Summary/Reason Statement for DRH12-00227

Planning Division Staff Report

File Number	DRH12-00227
Applicant	Glenn Levie
Property Address	916 E. Park Boulevard
Public Hearing Date	October 10, 2012
Heard by	Design Review Committee
Analyst	Josh Wilson
Checked By	Sarah Schafer

SITE PLAN

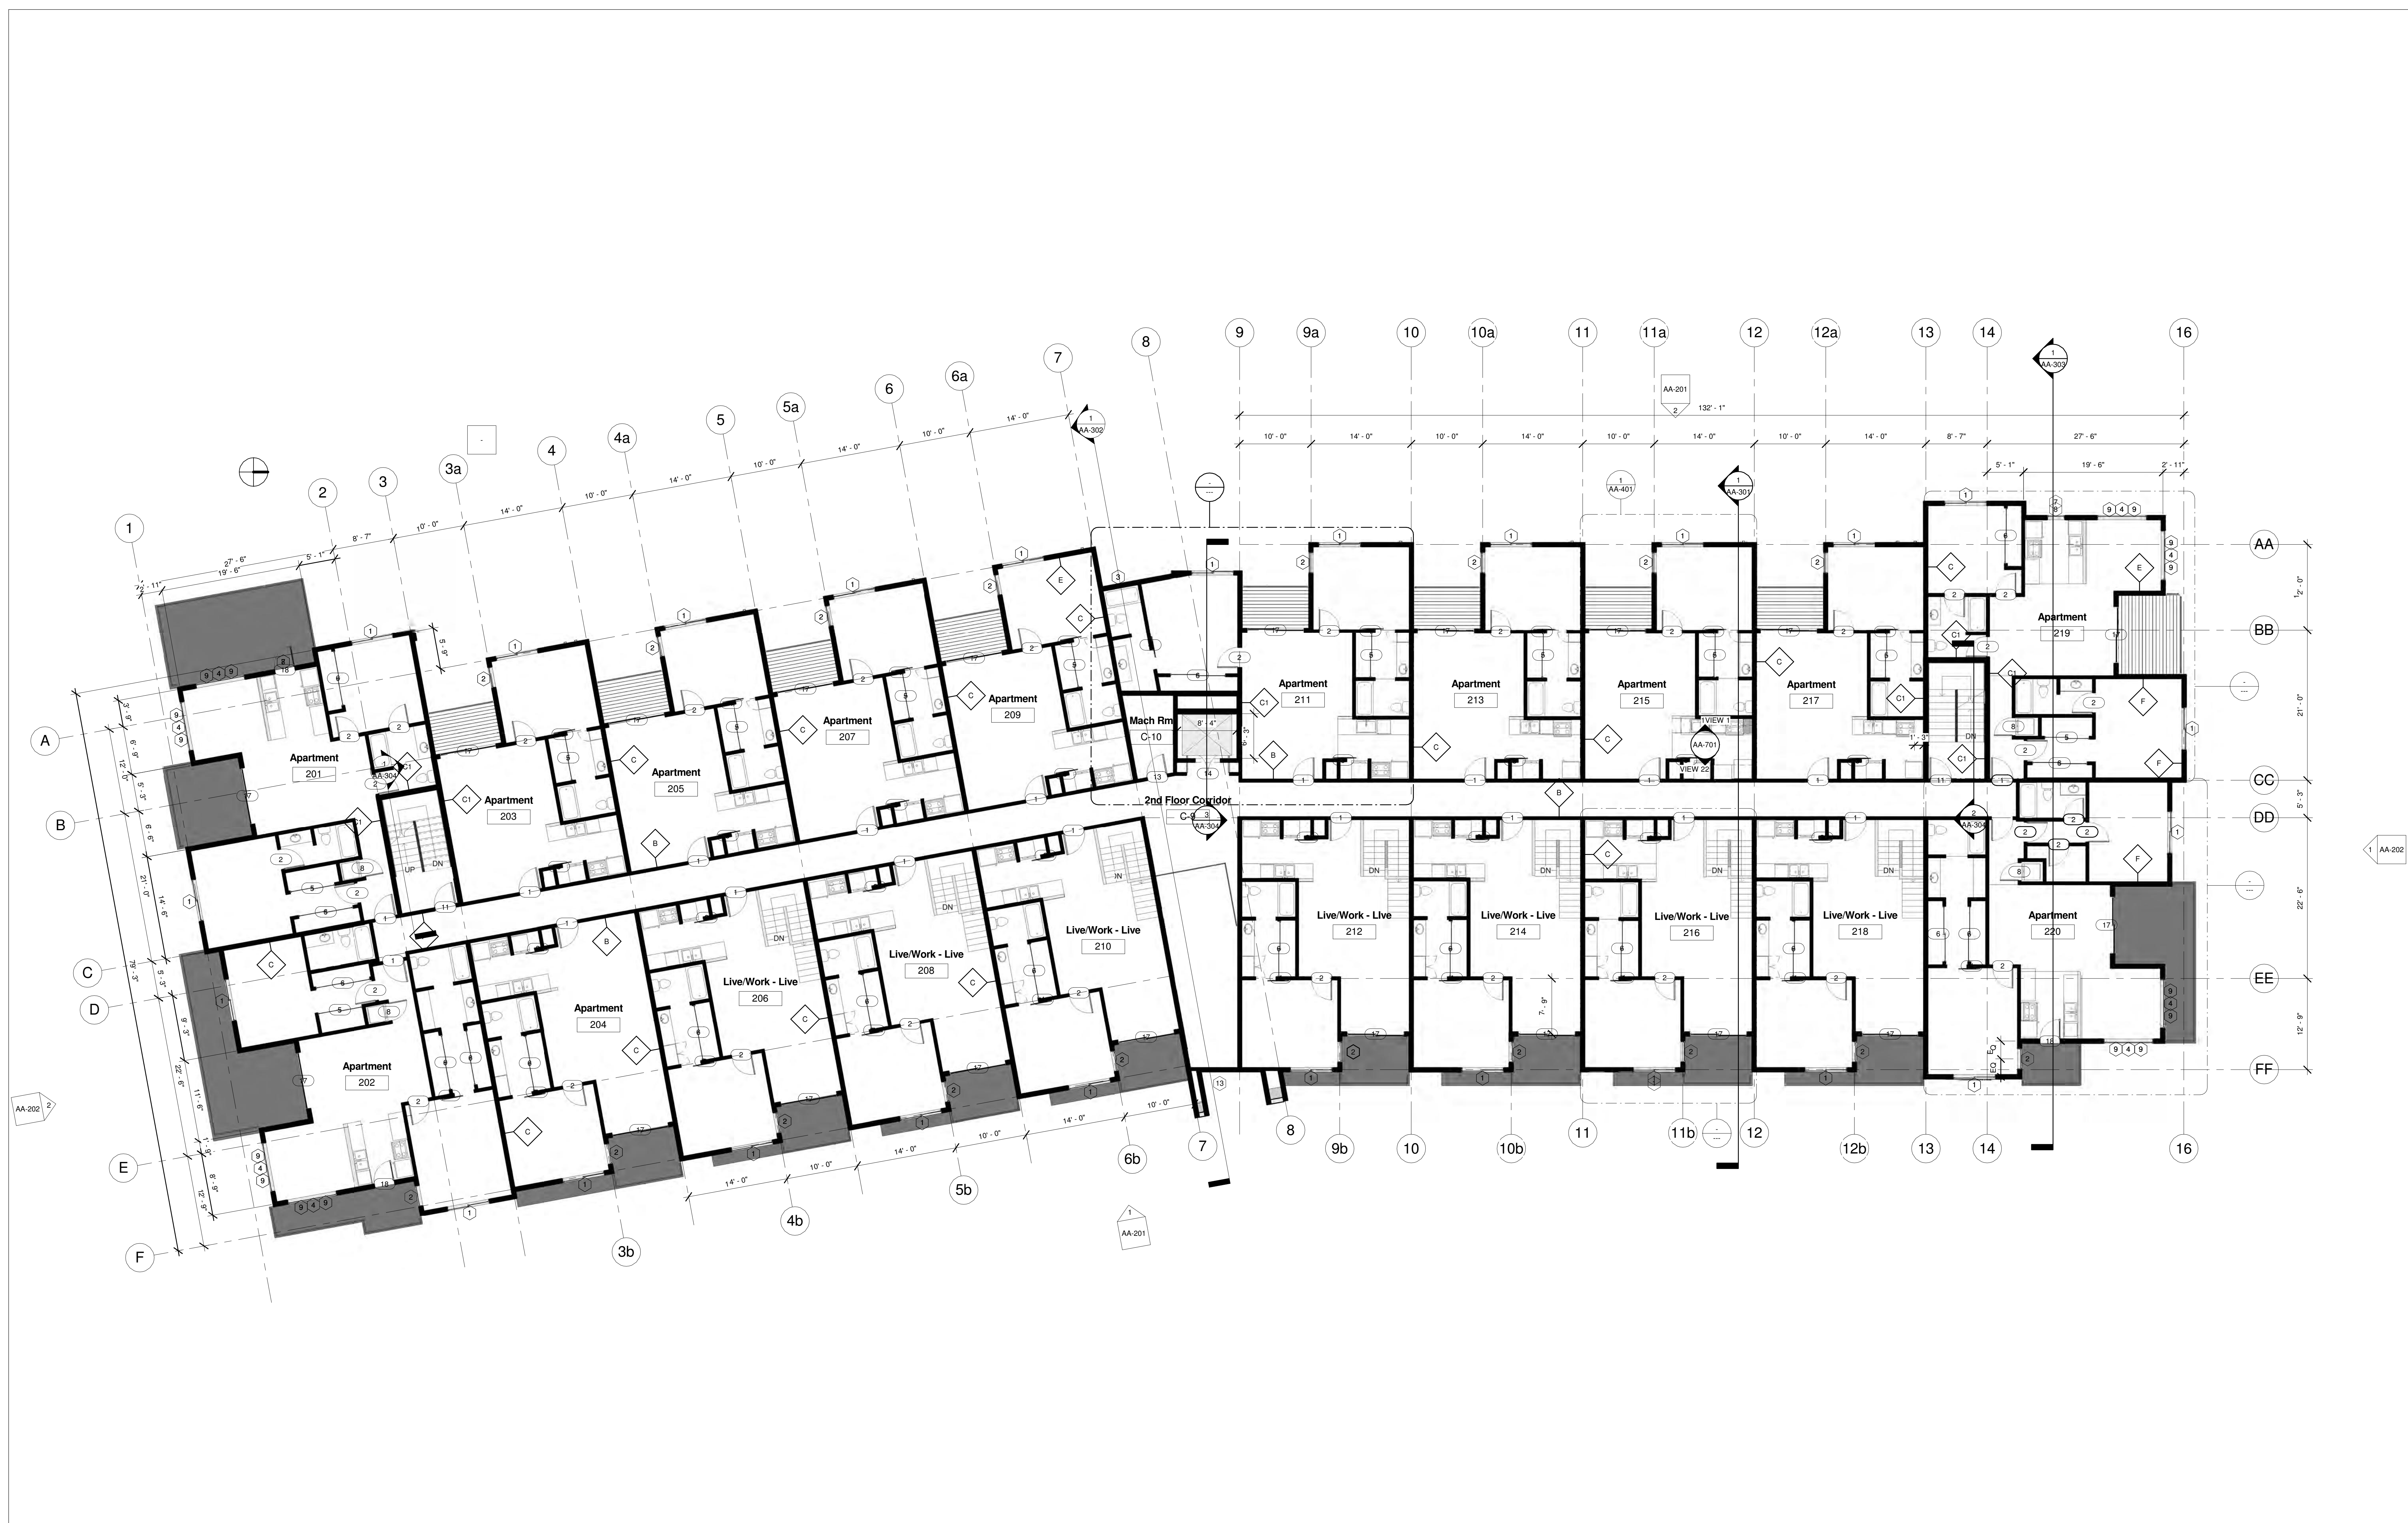
1. The trash enclosure should be centered on the drive aisle to provide the 50' of straight line access required.
